WORKSHOP AGENDA

Planning Commission

September 10, 2024 @ 5:30 PM

Item #: 3. **Item Title: Recommendation to the Board of Mayor and Aldermen for Subdivision Acceptance – Carothers Crossing Phase 2. Property located off Carothers Road. Requested by SEC Inc. PDR (Planned Density Residential) Zoning District.**

PROJ. # 18038 DATE: 9-27-2021 REV: 10-14-2021 FILE: CC-PHASE 2 DRAWN BY: ATS SCALE: 1" = 50' SHEET 2 OF 2

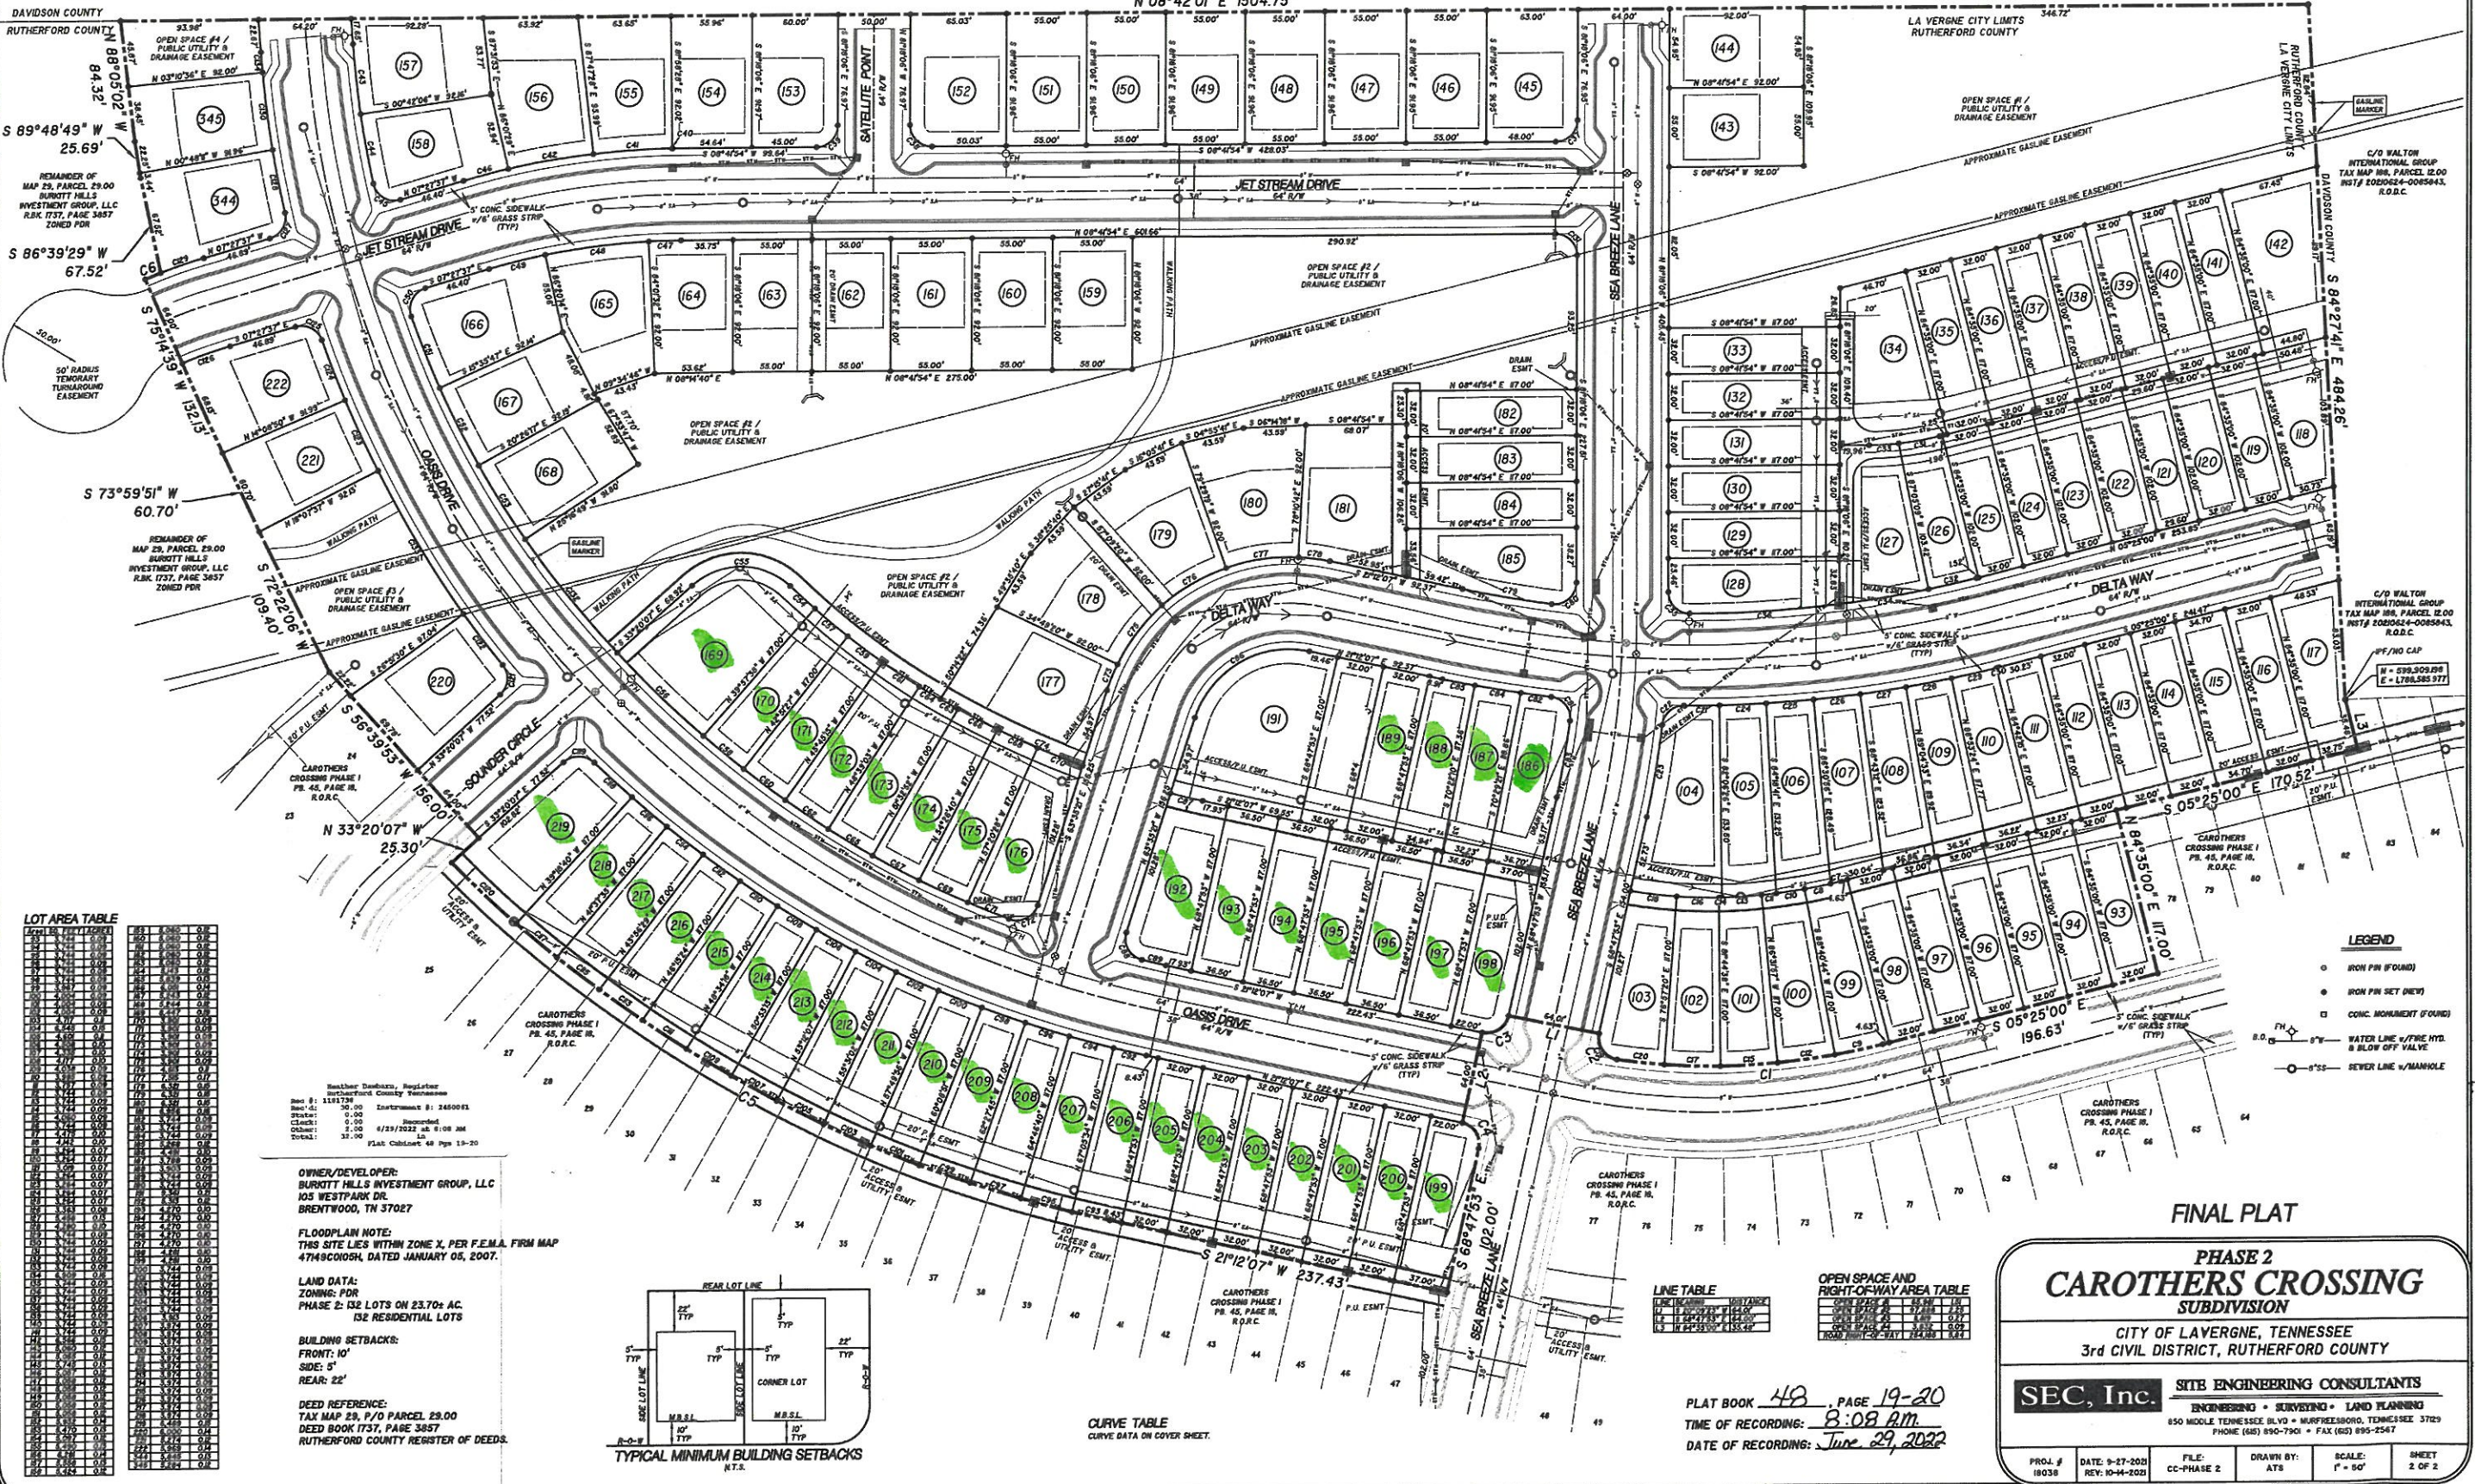
- Place 4" wide single solid white line (SSWL) striping separating streetside parking from driving lanes along all public roads as shown on plans.
- On Delta Way in front of address 336 there are two sections of concrete in the gutter line that needs to be chipped out

- Valve at rear of 300 Delta way is covered by a car, cannot access. No answer at residents to move car.
- FH in rear of 300 Delta way needs raised, currently at 14". Needs to be at 18" min.

- All curb and area inlet structures, headwall and pipe junctions need to be grouted with Portland cement.
- The area in front of all headwalls needs to drain as shown on the plans. If any area around the headwall have washed out or have silt build up that area needs to be reworked and stabilized with seed and matting.
- Remove all not needed erosion control.
- Be sure all inlet boxes are clean and drain properly.
- Check to be sure all pipes are clean and drain properly.
- Be sure all roads are clean.
- Be sure all drainage area drains as shown on the plans. if any area needs reworked that that area needs stabilized with seed and matting.
- All bare areas need stabilized with seed and straw or matting.
